IN THE MATTER OF Application RC 195454 - to establish a
supermarket and associated facilities at 581
Birchs Road, Lincoln

Evidence of Hugh Nicholson

03 July 2020

Figure 1: East elevation of the proposed supermarket building

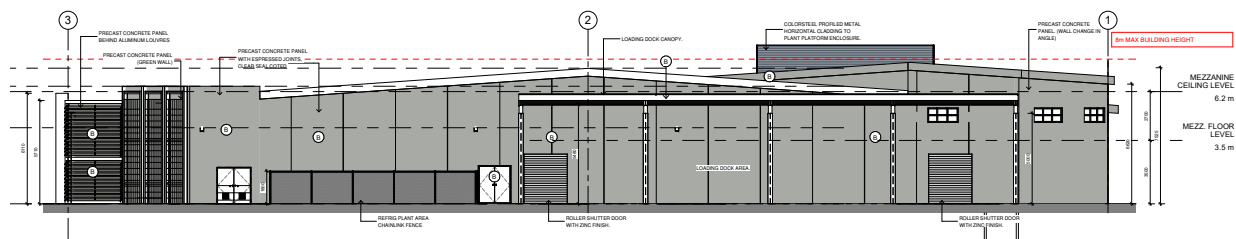
The site plan for the proposed supermarket shows a 15 metre wide service lane to the east of the building with a 3 metre wide landscape strip and acoustic fence along the eastern boundary. The eastern elevation of the proposed building is approximately 51 metres long and between 6 and 7 metres high,

constructed out of precast concrete panels with a clear seal. The elevation includes refrigerated plant, two roller doors, a high level canopy over the loading area, two double doors and three small windows into the mezzanine floor offices. The landscape strip is proposed to be planted with four trees and ground cover growing up to one metre in height.

- 4.3 I consider that the proposed three metre wide landscape strip and acoustic fence are not sufficient to mitigate the scale of the industrial façade or the associated manoeuvring and unloading of heavy vehicles in the service lane. In particular I note that the industrial activities occurring in the service laneway including visual intrusion from lights and moving vehicles, and noise from refrigeration plant and reversing signals at various times of the day and night throughout the week and weekend.
- 4.4 In my opinion the proposal for a loading bay and service laneway as shown on the drawings, together with associated industrial activities, would not be conducive to creating 'a pleasant place to live' and would reduce the residential amenity of the neighbouring properties.

- 4.5 The minimum acceptable mitigation that I would recommend in this situation would be to fully enclose the loading bay, and to provide an acoustic fence and an eight metre setback from residential neighbours including a five metre landscaped strip. In this instance the right of way on the neighbouring properties could provide part of the remaining setback.
- 4.6 *North Boundary*

Figure 2: North elevation of the proposed supermarket building

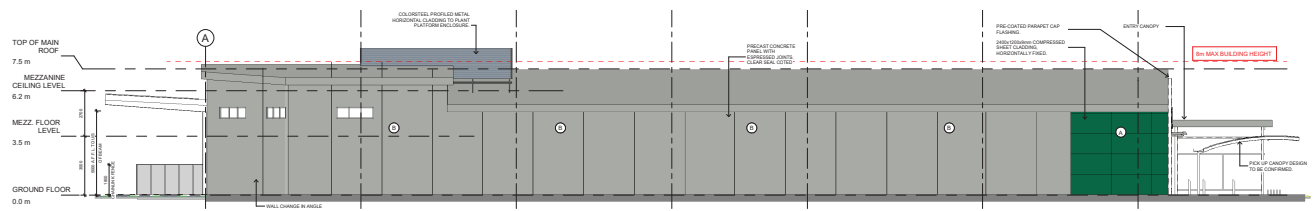
The land to the north of the site is zoned Living Z and residential development is anticipated in the future. The proposed supermarket is set back 4.95 metres from an acoustic fence along the eastern part of the northern boundary with a service lane between. The façade is more than 50 metres long and ranges from five to seven metres tall. There are three windows to the offices on the mezzanine floor.

- 4.9 In my opinion the proposed landscape strip, fencing and service lane along the northern boundary are not sufficient to mitigate the scale of the proposed supermarket and carpark or the adverse effects that the proposed supermarket activities are likely to cause for residential neighbours to the north. The building façade and the service yard activities in the eastern part of the site are industrial in scale and the only attempt at screening or mitigation is an acoustic fence.

Figure 4: South elevation of proposed supermarket including signage

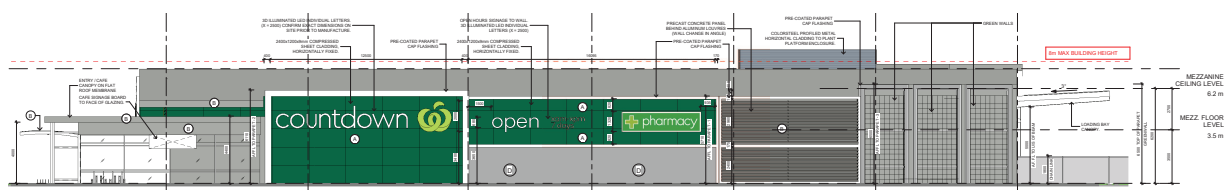
9.3 There are two Countdown signs with illuminated letters and logos, one proposed on the western façade and one on the southern façade. Both would be 11.5 metres long and 2.0 metres high. There are also a 'Pick Up' sign on the western façade and an 'open' sign with hours of opening on the southern façade, both with illuminated letters approximately 750mm high. There is a 'Pharmacy' sign on the southern façade which is not labelled as illuminated.

9.5 The signs on the southern façade do not need to be visible from a distance and the 'open' and pharmacy signs directly face 14 Caulfield Terrace across the proposed road. If the application is approved I would recommend that these two signs are moved to the western end of the southern façade away from the residential neighbours.
